CRAWFORD JANNEY SANITARY SEWER REPLACEMENT

PLAN AND PROFILE STA 00+00 To STA 4+80

Drawing No.:
C-101

1 PLAN VIEW

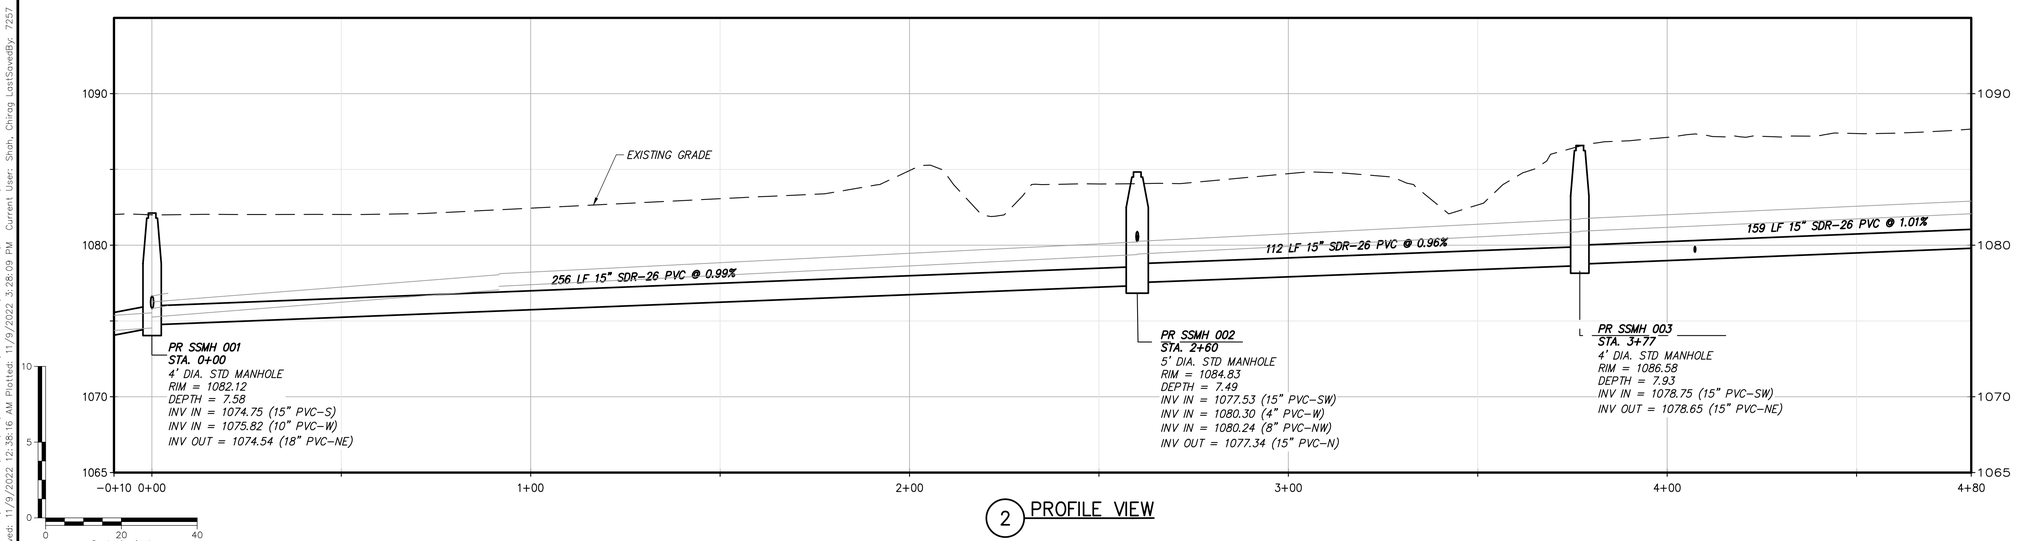
Shifted SSMH 002 appox. 6' to avoid conflict with existing manhole. 4" and 8" connections made inside new manhole as shown.

Shifted SSMH 003- 4' to avoid conflict with existing structure

Installed 18" x 12" Wye to make temporary connection with existing 12" line. Temporary connection was removed and the 12" side of the Wye plugged at project completion.

Relocated Gas Main to make connection

Red line is new location of new sewer Main
